RFP-MCC-2405
Build of a New Fire Station Located in Springhill NS
Addendum #4

The following question has been received by an interest party relating to this RFP.

PID 25258468

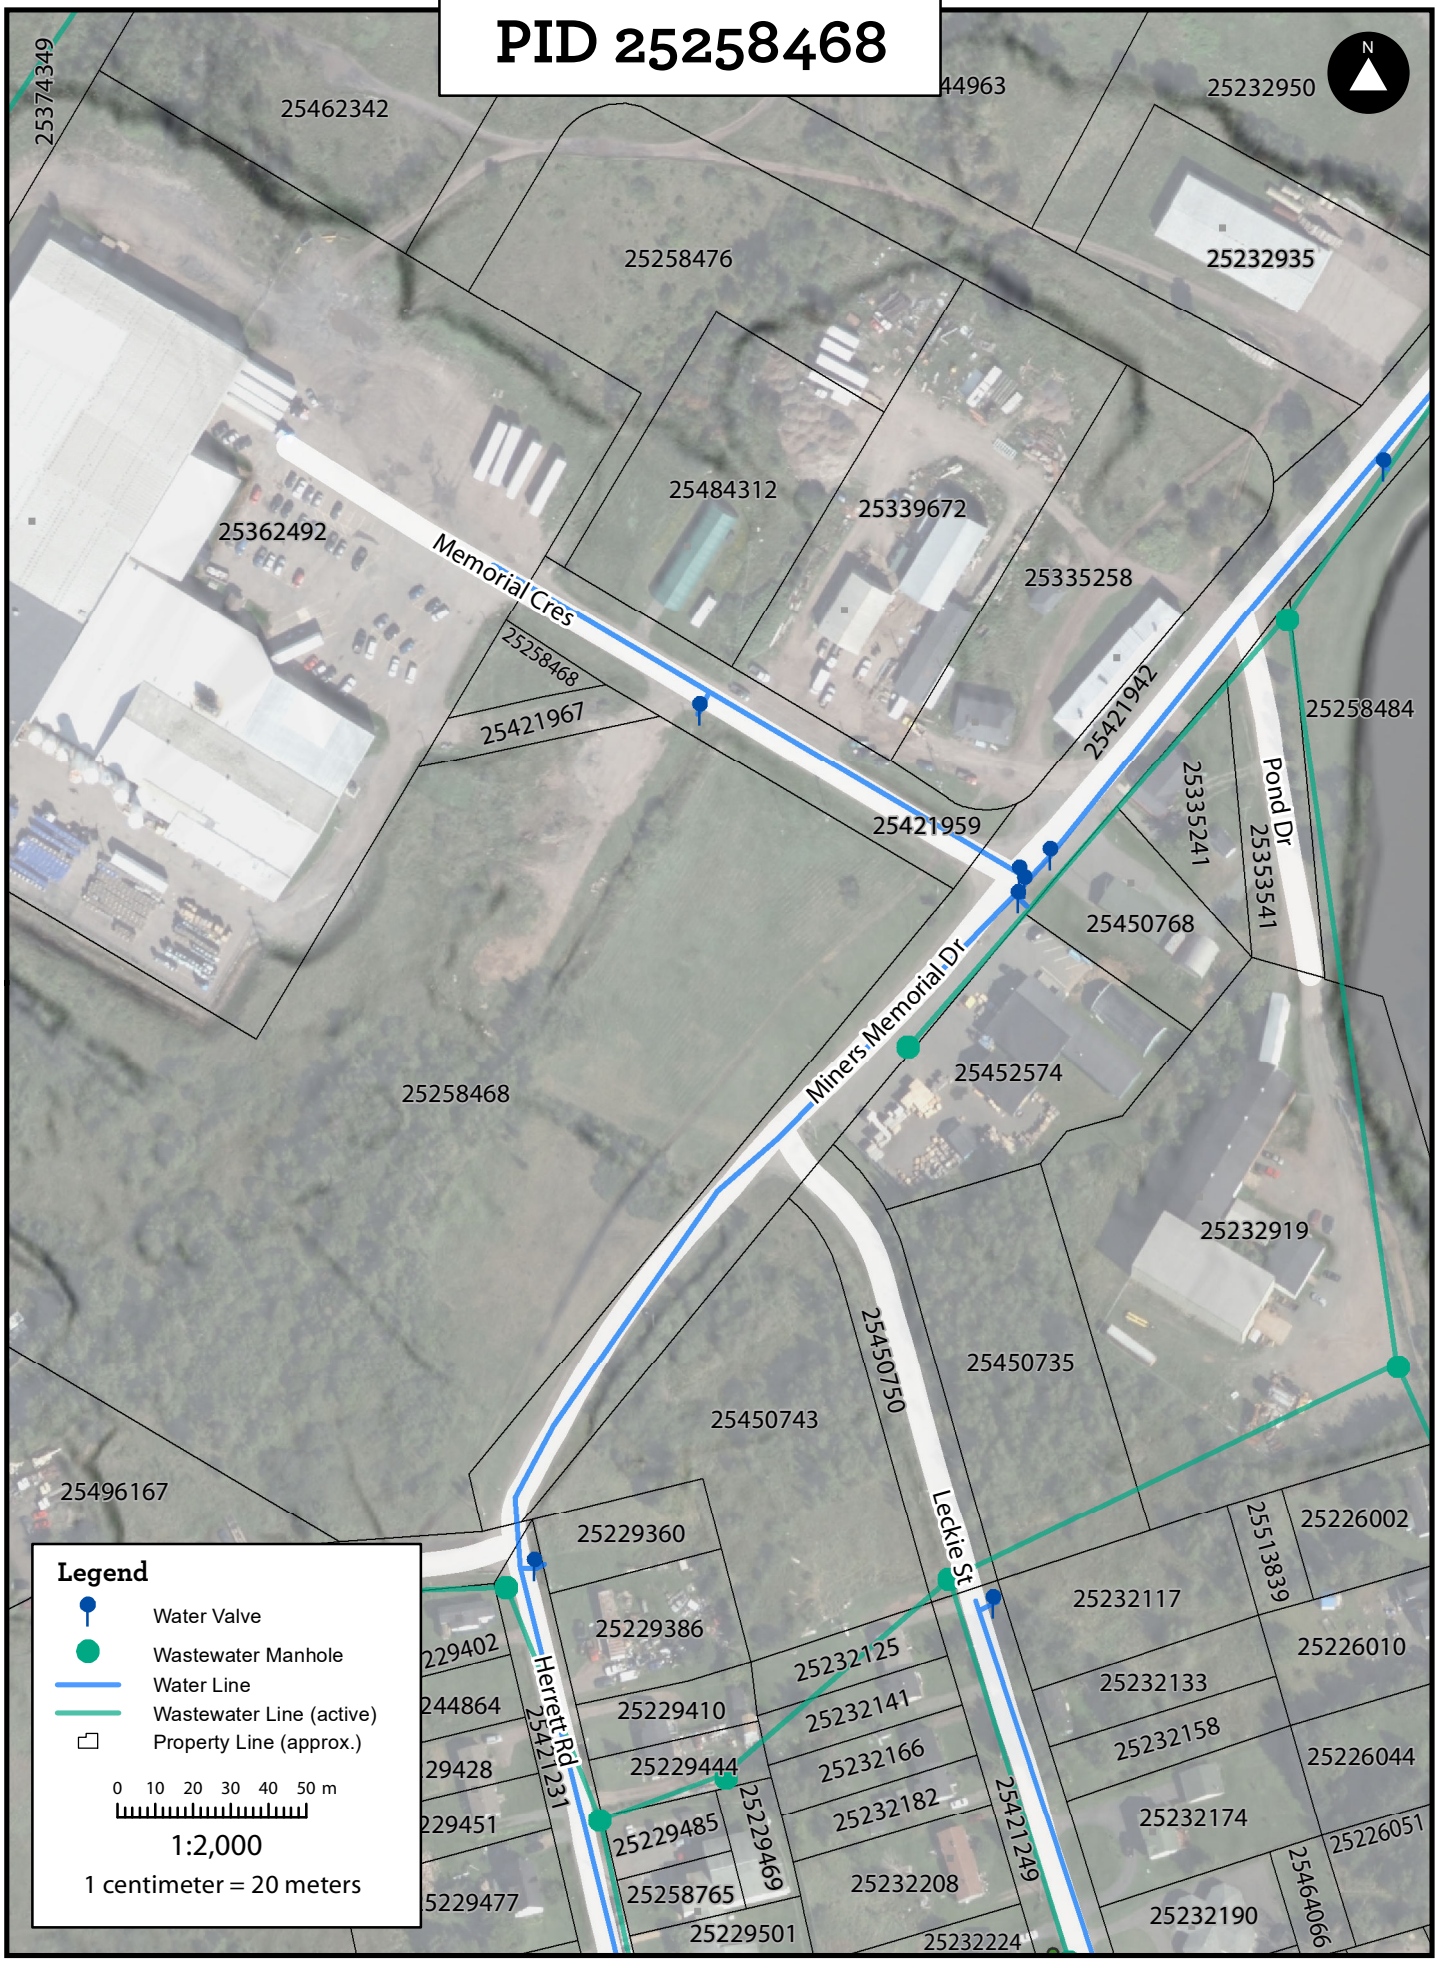
c. Page 11 of the RFP states 'the utilities in Springhill include a 200mm concrete sanitary sewer and a 350mm ductile iron watermain' but does not include any further information regarding record drawings, depths, location, etc. Can this be provided.
    There are no as-built plans available for this area. Recent hydrant pressure tests are included for reference. The approximate location of municipal infrastructure from the Municipality's GIS database are shown on the attached plan.
